LUXE

Apple recently made some updates to their iPad product line back in September and announced the iPad 7th gen 10.2 - inch. This new iPad is the same height and length as the iPad Air 3rd gen. 10.5 - inch, **HOWEVER** it is 1.4mm thicker. Also the camera locations shifted slightly. As a result we needed to make a few changes to our existing product line to accommodate the thickness of the new iPad.

What has changed.

LUXE Packaging

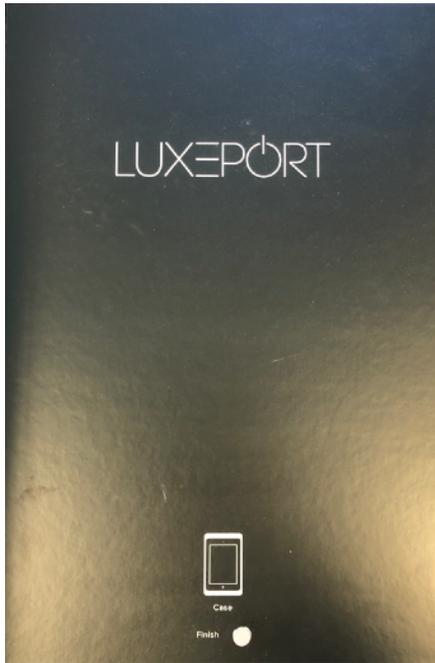
How to identify old vs new IPORT product:

OLD 10.5 LUXE - Old Black LUXE packaging. Old iPort Logo. Packaging will only say iPad Pro 10.5-inch Compatible.

NEW 10.2 | 10.5 LUXE - New grey packaging, new IPORT logo, Outer packaging will say iPad 10.2-inch (7th gen) | iPad Air 10.5-inch 3rd gen. compatible.
